Technical Bulletin: Date: November 8, 2010

Subject: L9684F

Profile Comparison: New Design vs. Previous Design

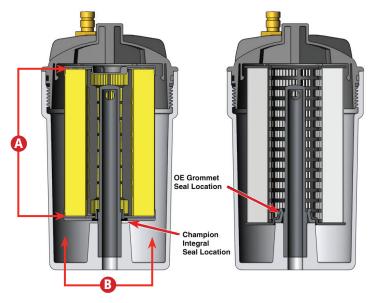
New intergral seal replaces OE grommet seal thus creating a shorter profile by 0.120"

- A The overall height of the L9684F is now approximately .120" shorter than the previous filter. This is due to the use of a seal that is integral to the open end cap instead of a grommet. The sealing diameter is still located at the appropriate elevation to provide a proper seal in the housing.
- B Additionally the closed end of the filter element is now the same diameter as the open end. This will not affect the performance of the filter in the application however the filter no longer snaps into the housing cap for installation and removal. The overall filter diameter is smaller than the OEM filter as well.
